8. Well Name and No.  
"Pre-Ongard" Well #6 AKA Lydia Rentz #6

9. API Well No.  
30-039-05878

Re: Permanent Abandonment  
Well: 6 Lydia Rentz

CONDITIONS OF APPROVAL

**Lydia Rentz #6**  
**Rio Arriba County, New Mexico**  
**Proposed well bore schematic**

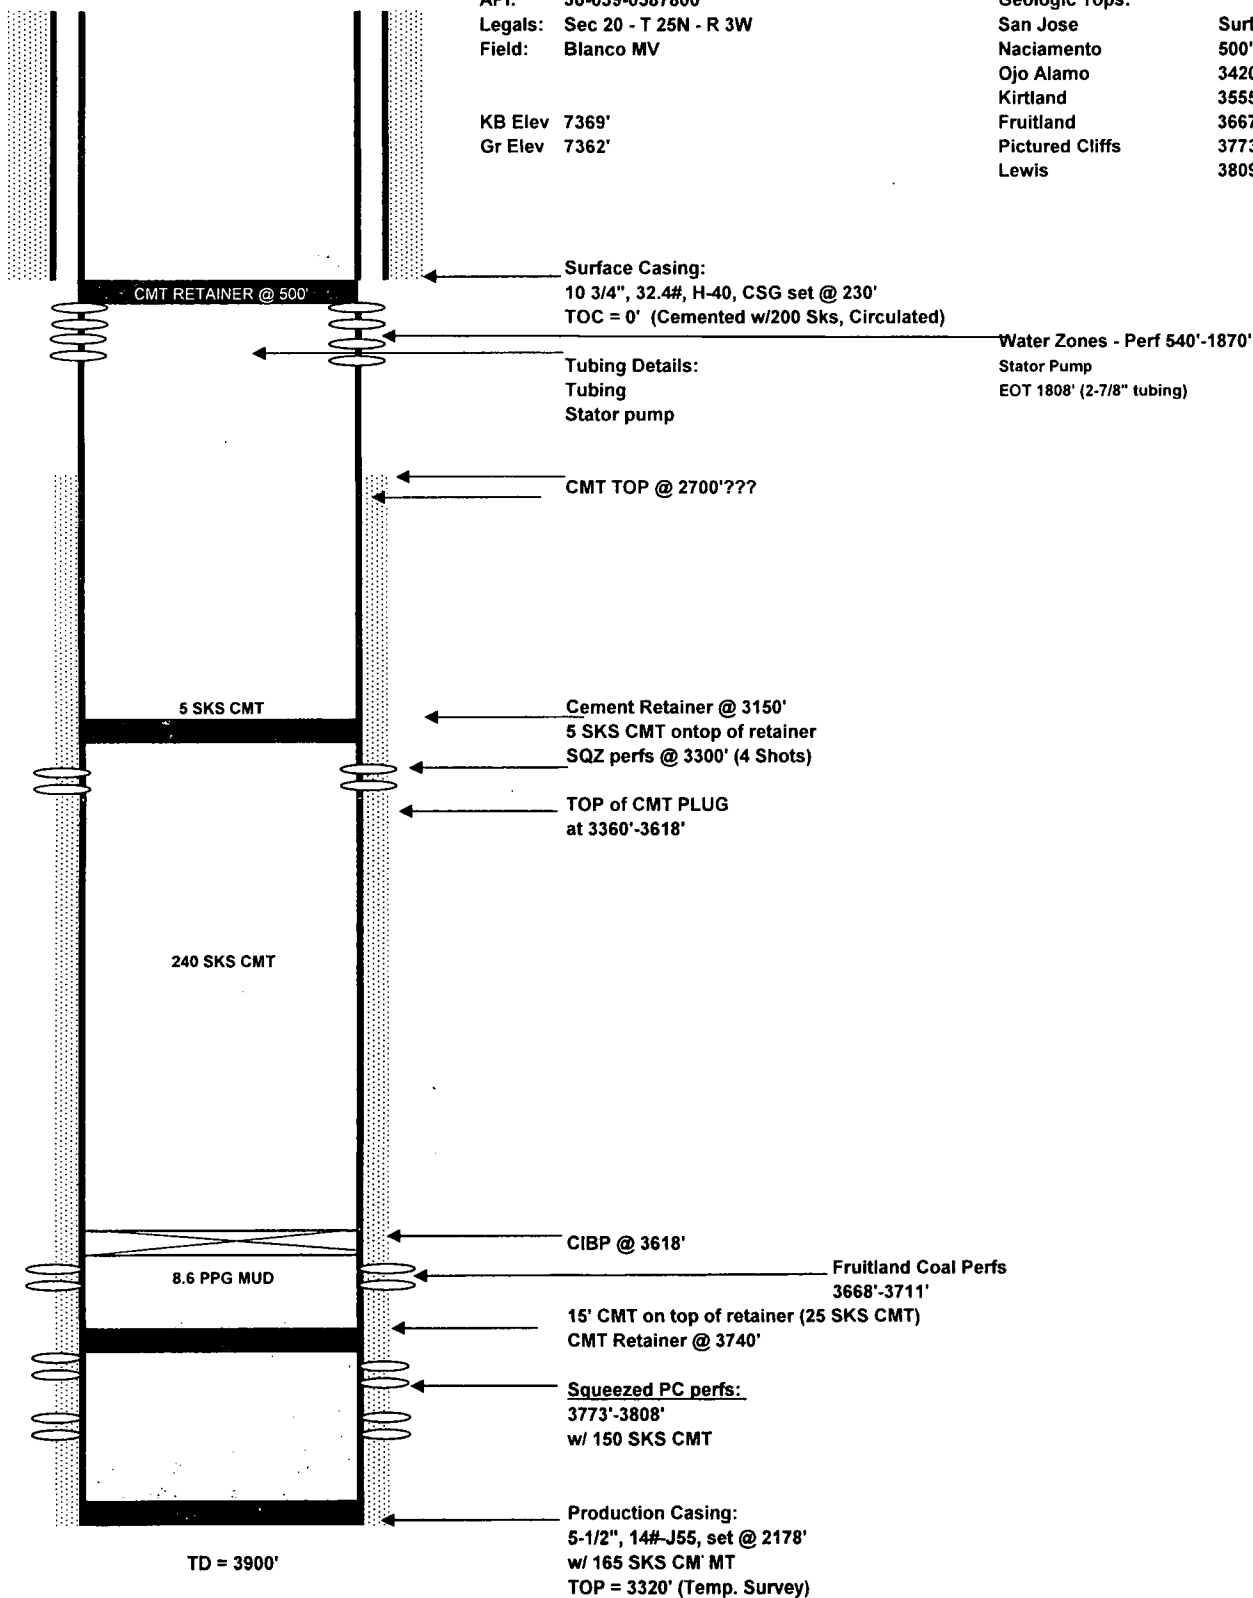
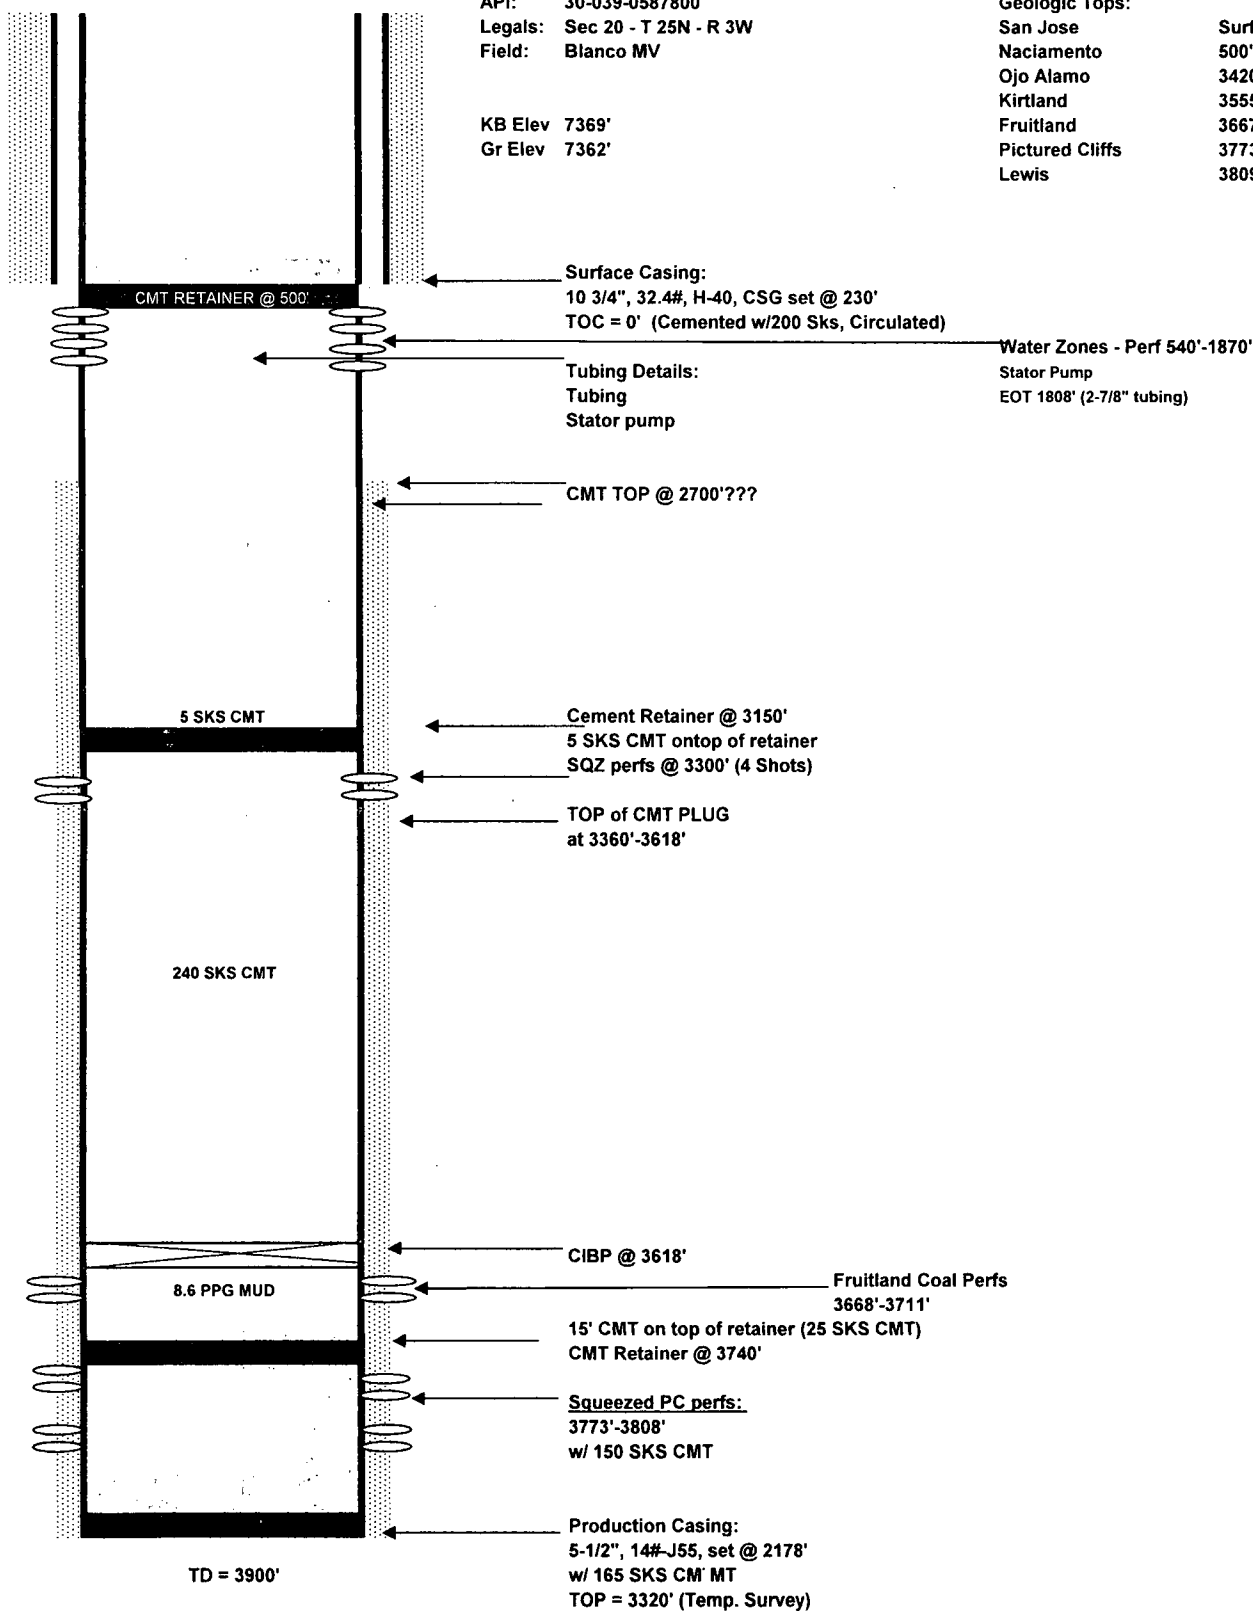
1. Plugging operations authorized are subject to the attached "General Requirements for Permanent Abandonment of Wells on Federal and Indian Lease."
2. Farmington Office is to be notified at least 24 hours before the plugging operations commence (505) 564-7750.
3. The following modifications to your plugging program are to be made:
  - a) Place a cement plug from 2138' – 2038' to cover the Nacimiento top inside and outside the 5 ½" casing.
  - b) Place the Surface Casing Shoe plug from 280' – 180'.

You are also required to place cement excesses per 4.2 and 4.4 of the attached General Requirements.
